Cc: lynch@ltmblaw.com; Susan LaFond; 'Ronald Wassmer' FW: 615 Plains Road - Extension; Traffic Study Update. **Subject:**

Subject: 615 Plains Road - Extension; Traffic Study Update.

DATE OF SUMMARY: Revised, 2/22/22 HEARING DATE: March 1, 2022

<u>APPLICATION REQUEST:</u> <u>Special Exception with Site Plan and CAM Review</u>

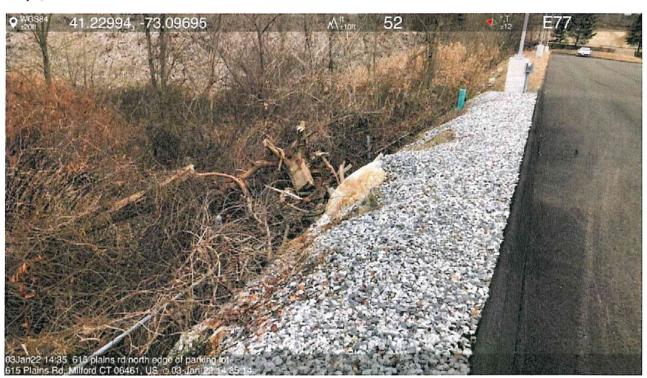
There appears to have been a boulder and concrete block retaining wall and fill installed for the leveling and construction that has been completed. No silt fencing was visible on the site. In Photo 2, black fabric is against the fence next to the fill slope; I could not safely access to determine it is silt fencing and no other erosion controls are apparent at the base of the slope on the east and west sides of the site where the boulders and concrete blocks were installed. There is a sedimentation and erosion control plan in the plan set entitled "Site Plan 615 Plains Rd, Milford, Connecticut" by CT Civil Group, cover & 9 sheets, dated as follows: T-1, Ex-1,Sp-1, GDU-1, ES-1, IP-1, IP-2, D-1,D-2: 12/01/20 Rev 5/24/21; LS-1, A-1 & FP-1: 5/24/21. It cannot be determined if the sedimentation and erosion control measures were adhered to during construction.

Portions of the slope have small gravel and grass. Portions do not have stabilizing vegetation. No plantings from the proposed planting plan received in the P&Z transmittal were apparent. Given the season the slopes cannot be properly stabilized until the spring. See photos 2, 3 & 4. The P&Z transmittal of the proposed work did not include a cross section to show how the base of the slopes would be constructed or stabilized.

Photo 4 facing east fill over boulder / block retaining wall with loose soil.

Photo 5 facing east fill over boulder / block retaining wall with gavel and loose soil.

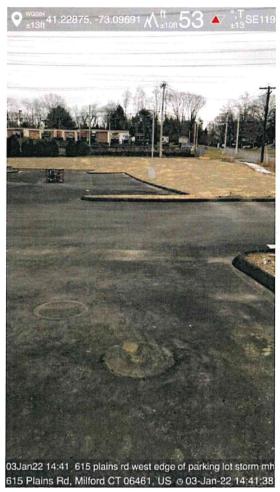
Catch basins are installed and appear to be functioning on the 615 Plains Rd property. Seven (7) stormwater manholes are located in the front parking area on either side of the entrance from Plains Road. There is no information or inspection of these structures during construction to ensure proper installation and functioning. There is no annual stormwater maintenance plan or manual for these structures or the property in the documents I received. Photos 6 & 7 show the manhole locations approximately as shown on above referenced proposed site plans.

Photo 6 facing southwest at Plains Rd. Five(5) manholes for stormwater system.

Photo 7 Facing southeast towards Raton Dr. Two(2) manholes for stormwater system.
